UNITED STATES
DEPARTMENT OF THE INTERIOR
BUREAU OF LAND MANAGEMENT

SUNDRY NOTICES AND REPORTS ON WELLS
Do not use this form for proposals to drill or to re-enter an abandoned well. Use form 3160-3 (APD) for such proposals.

1. Type of Well <input checked="" type="checkbox"/> Oil Well <input type="checkbox"/> Gas Well <input type="checkbox"/> Other		8. Well Name and No. TONY FEDERAL 44
2. Name of Operator APACHE CORPORATION		9. API Well No. 30-015-40389-00-X1
3a. Address 303 VETERANS AIRPARK LANE SUITE 3000 MIDLAND, TX 79705	3b. Phone No. (include area code) Ph: 432.818.1167	10. Field and Pool, or Exploratory CEDAR LAKE
4. Location of Well (Footage, Sec., T., R., M., or Survey Description) Sec 18 T17S R31E SWSE 370FSL 2350FEL		11. County or Parish, and State EDDY COUNTY, NM

Apache Corporation proposes to use a 13-5/8" 3M psi WP BOP (EXHIBIT 3) consisting of an annular bag type preventer. The BOP will be nipped up on the 13-3/8" surface csg head & tested to 2000psi using a test plug. After intermediate csg is set & cemented a 13-5/8" or a 11" 3M BOP consisting of an annular bag type preventer, middle blind rams, and bottom pipe rams (see EXHIBIT 3A) will be installed & utilized con

**13-5/8" 3M psi
BOPE & Choke Manifold
EXHIBIT 3**

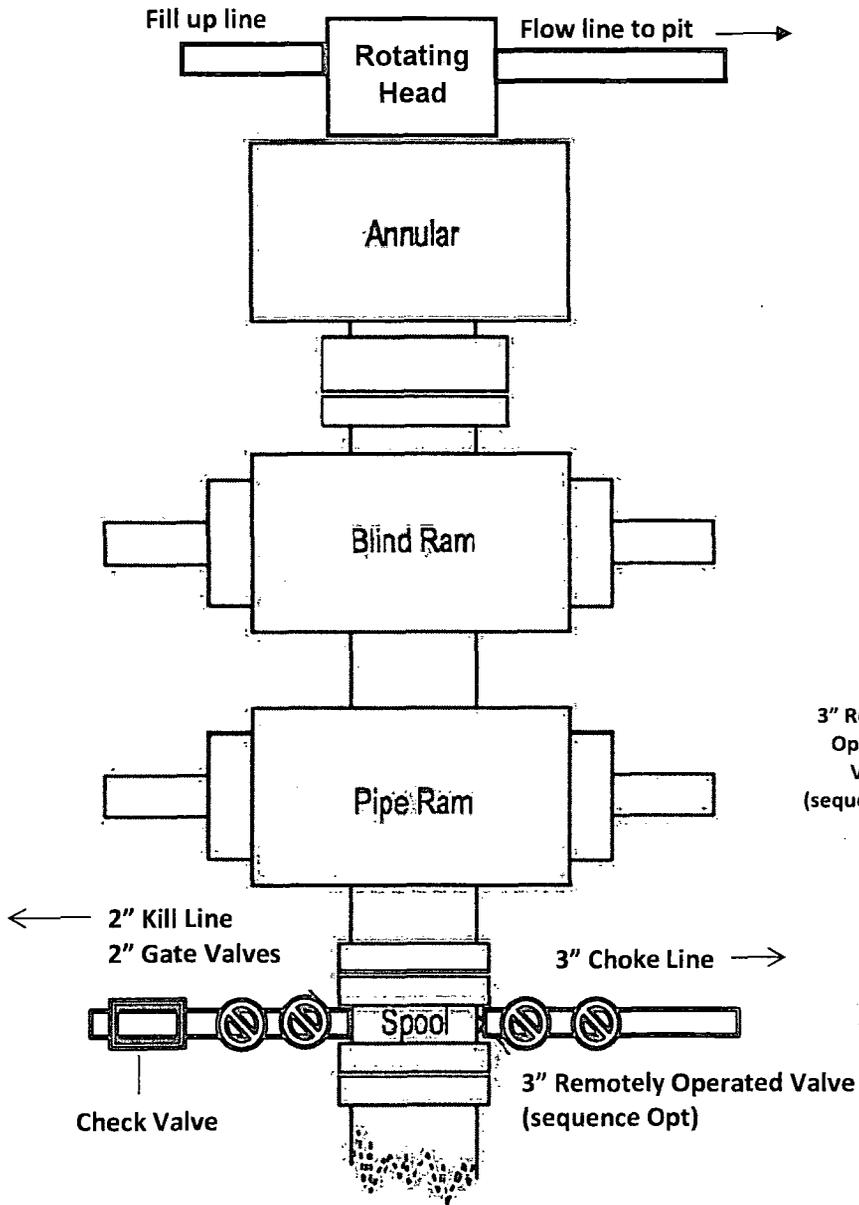
stabbing valve & kelly cock will be on derrick floor in case of need. No abnormal pressures or temperatures are expected in this well. No nearby wells have encountered any well control problems.
